Parent Item Name: Service Deck Drain Line Assembly

E4736-043 SERVICE DECK DRAIN LINE ASSEMBLY

DESIGN	<i>[Signature]</i>	EAGLE COPTERS LTD CALGARY, ALBERTA, CANADA	
DRAWN	<i>[Signature]</i>	DRAWING NO.	REV. A
CHECKED	<i>[Signature]</i>	E4736	SHEET 2 OF 5
MFG. APPR.	N/A	TITLE	SCALE
APPROVED	<i>[Signature]</i>	DRAIN LINE	NTS
DE APPR.	<i>[Signature]</i>	COPYRIGHT © 2012 BY EAGLE COPTERS LTD	
DATE	12.11.01	THIS DOCUMENT IS PRIVATE AND CONFIDENTIAL AND IS SUPPLIED ON THE EXPRESS UNDERSTANDING THAT IT IS NOT TO BE USED FOR ANY PURPOSE, OR COPIED OR REPRODUCED, WITHOUT THE WRITTEN PERMISSION FROM EAGLE COPTERS LTD.

From: Harvey Siemens
Sent: March-08-16 3:52 PM
To: William Monterroza
Subject: RE: E4736 issues with the sleeve coupling

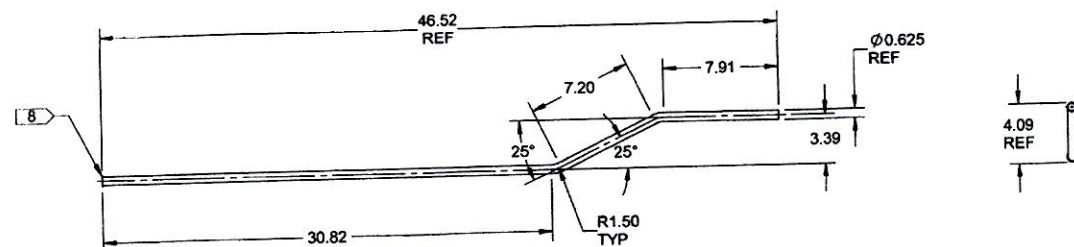
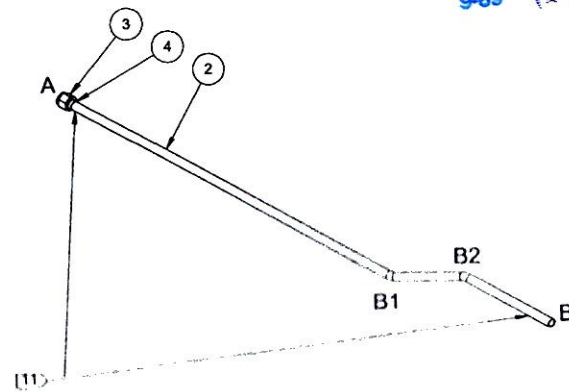
Change of Item 4 to MS20819-10D is acceptable to Engineering *[Signature]* MAR 23 2016 DAS 30 9-89 Dr GST 042

The drawing E4736 (attached) calls out for sleeve couplings MS20819-6J/-10J on the different configurations within the drawing.

Assembly pointed out that the -6J and -10J are stainless steel couplings, and they figure that these should really be -6D and -10D sleeve couplings, which they have stock of.

I see in the Spec for MS20189 that the Code D is inactive for new design or replacement parts, and they claim to use no code or Code J or K. Seems a bit off that even though this is stated, we would put aluminum and steel together for galvanic corrosion reasons. Do you know have any opinions on what they should use?

Yes, those sleeves should be the "D" version or whatever the call out is for them to be aluminum.
